Addendum No. 01

Project Name: SLCC Inclusive Restroom Addition

Project No.: 2022560.01

Issued: 12/5/2023

SECOND FLOOR REFLECTED **CEILING PLAN**

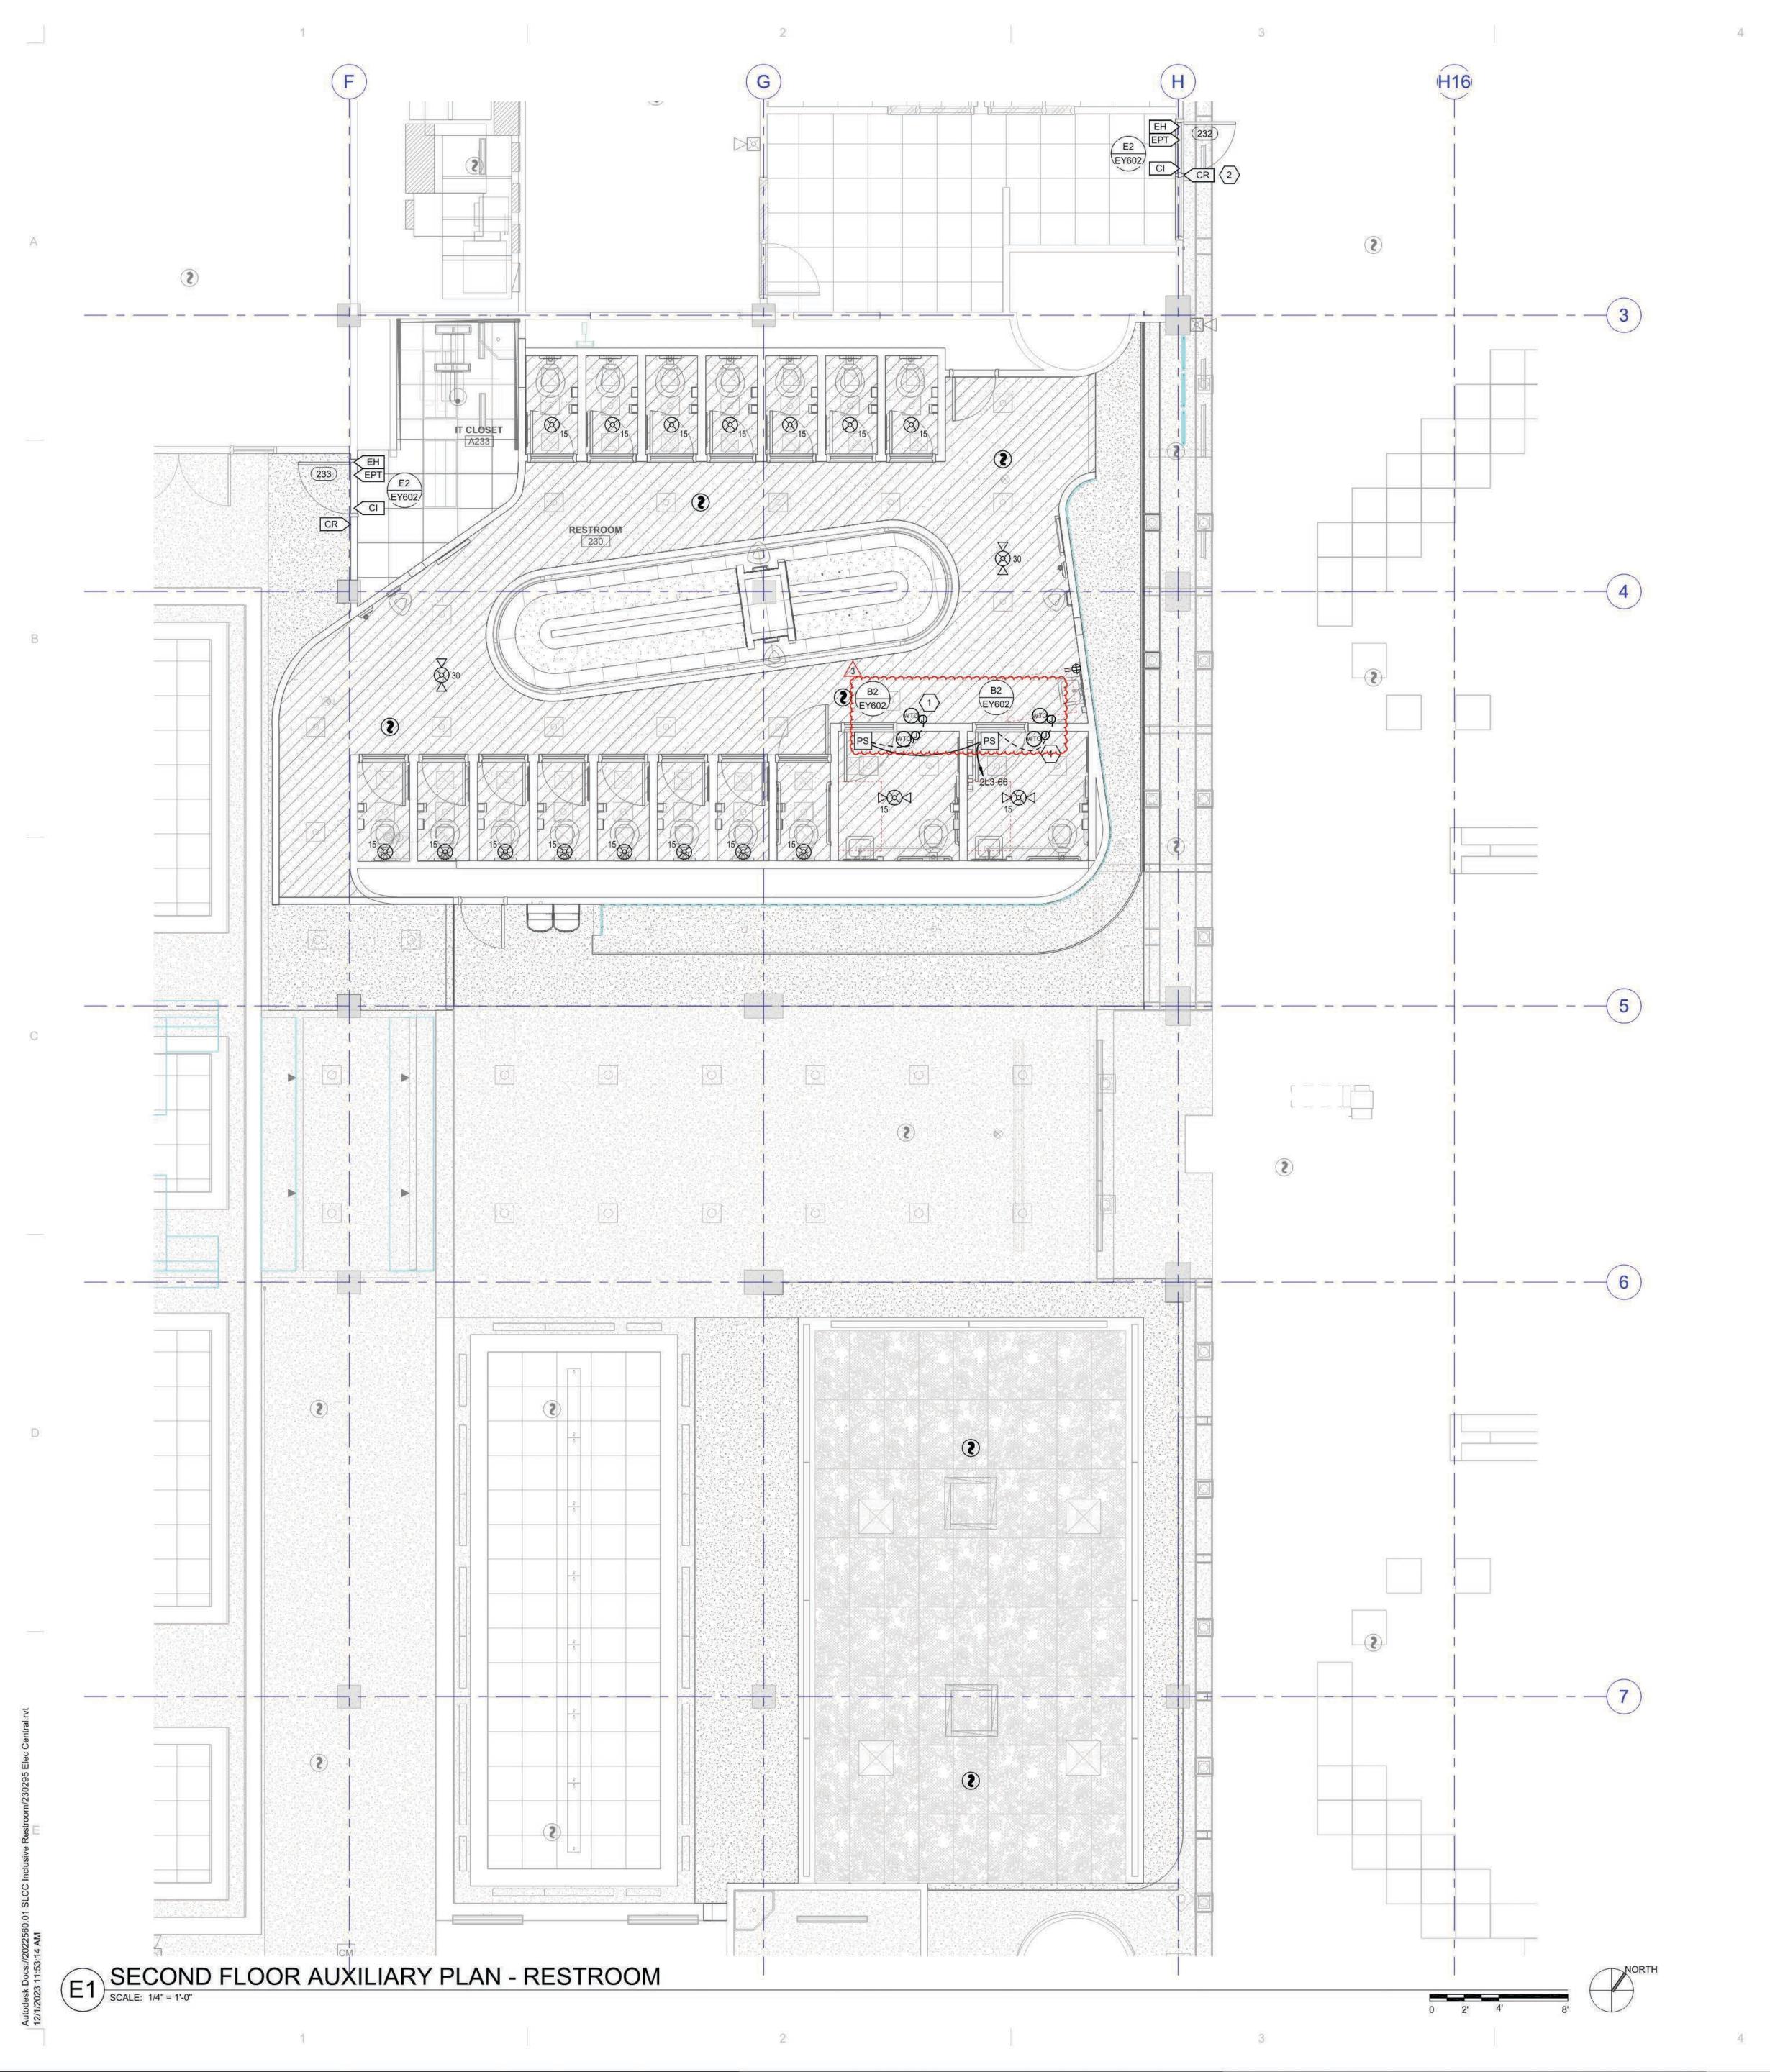
- B1.11 Sheet A702 SECOND FLOOR REFLECTED CEILING PLAN:
 - Ceiling tags revised, legend revised, and keynotes 1 & 2 clarified.
- B1.12 Sheet EY102 Second Floor Auxiliary Plan:
 - Updated ADA door to have "Wave-to-Open" device (WTO) tag instead of "HC" device tag.
- B1.13 Sheet EY602 Auxiliary Riser Diagrams:
 - Updated Detail B2 to show "Wave-to-Open" device (WTO) instead of ADA push button.

- 1. **Question:** Can you please clarify keynote 1 & 2 on sheet A702? 1. EXISTING OAK TRIM TO REMAIN. 2. PROVIDE SALVAGED OAK TRIM ALONG SOFFIT. SEE UPDATED SHEET A702.

- Question: The drywall ceilings outside of the restroom are called out as GB1 on the reflected ceiling plan. This is an epoxy paint as per the finish schedule. Is this correct? It won't match the existing lobby ceiling. THE CEILINGS OUTSIDE OF THE RESTROOM HAVE BEEN REVISED TO GB2, PAINTED GYP. BOARD TO MATCH EXISTING. SEE UPDATED SHEETS A702 AND A640.

LEVER TRIM DEVICE DETAIL

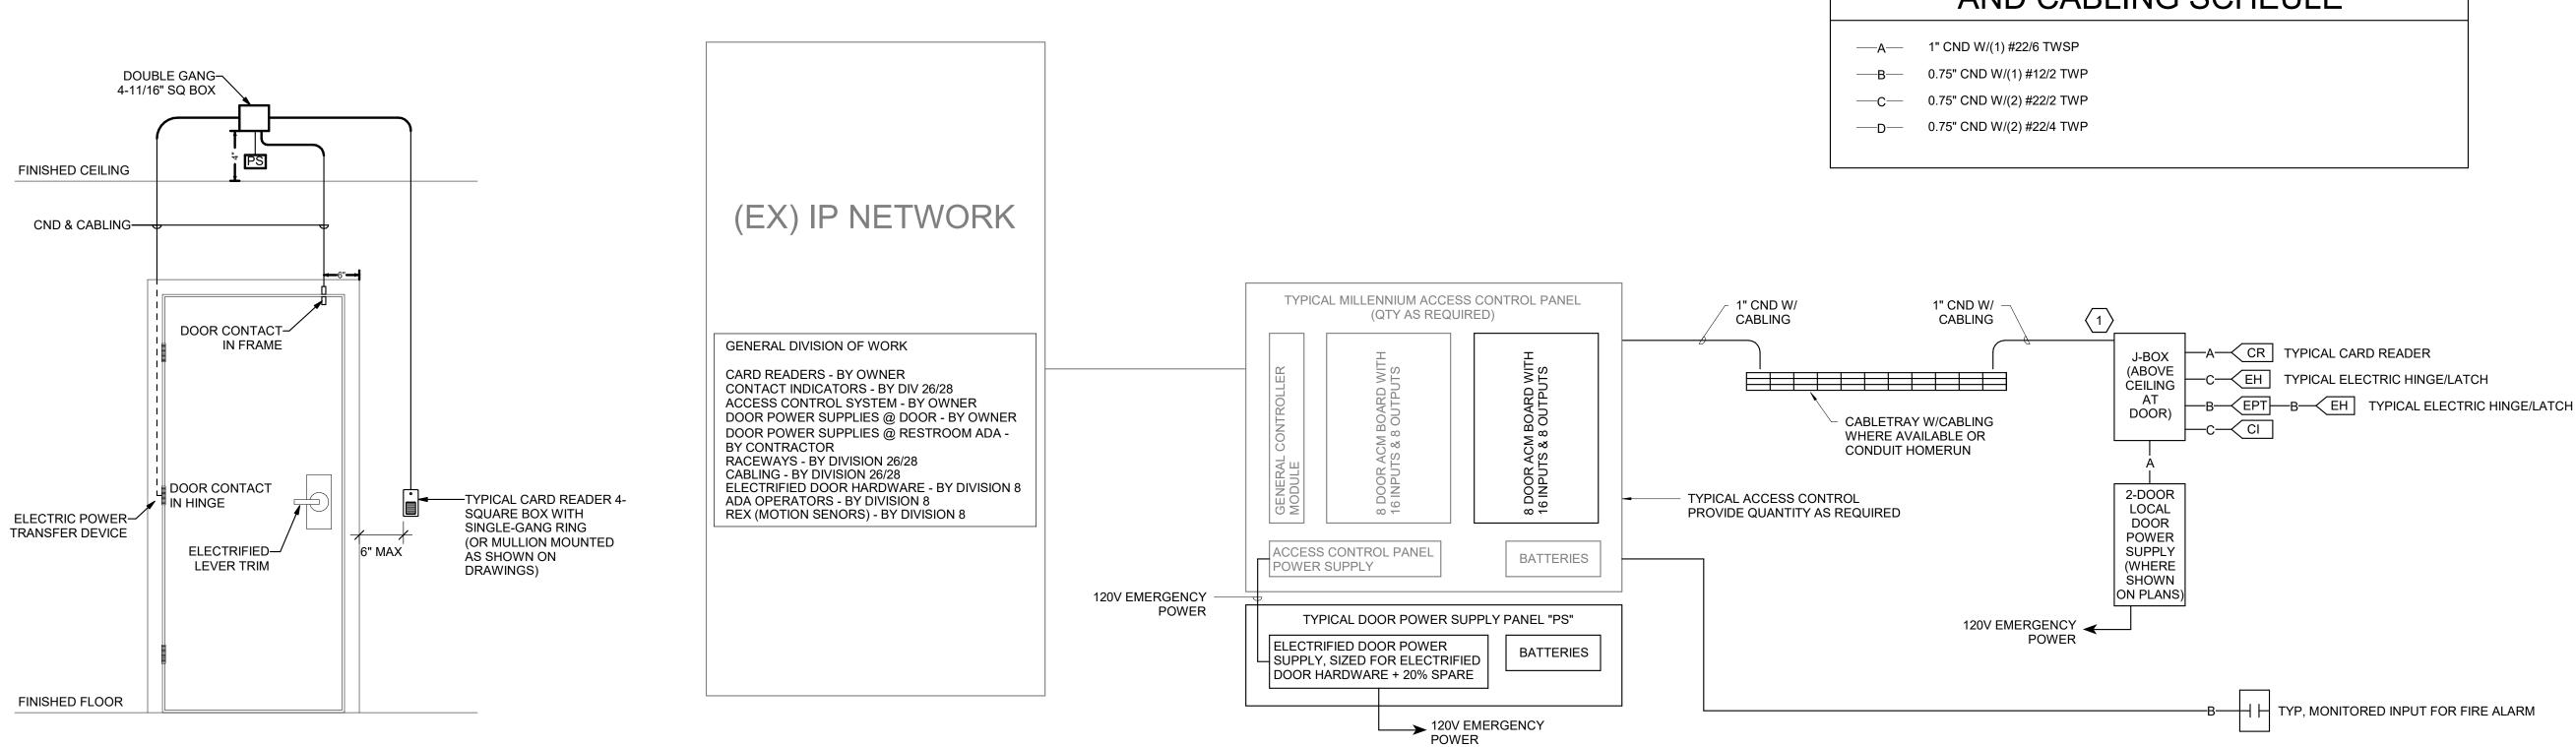
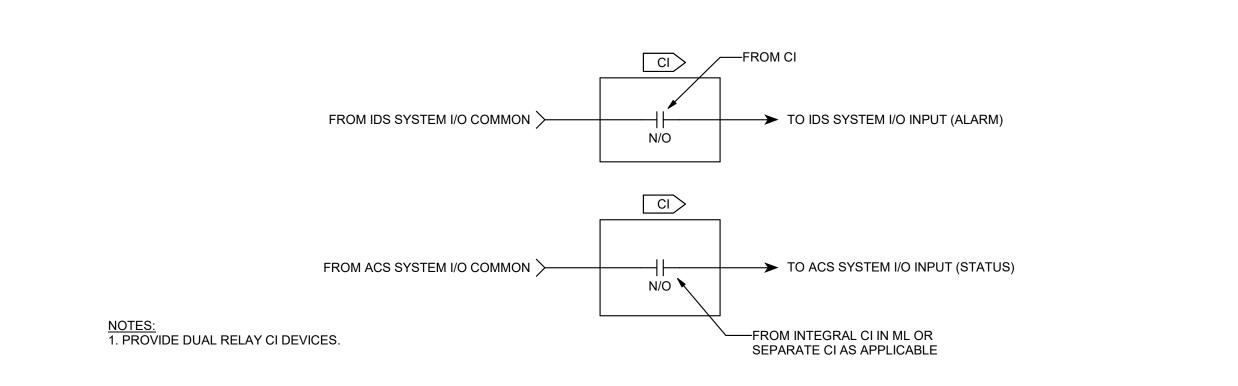
- 1. EY102: Has the following adjustments and clarifications. See attached.
 - a. Adjusted ADA door to have "WTO" device tag instead of "HC" device tag.
- 2. EY602: Has the following adjustments and clarifications. See Attached.
 - a. Adjusted "Restroom ADA Door Electrified Lever Trim Detail" to have Wave-to-Open device in stead of ADA push button.
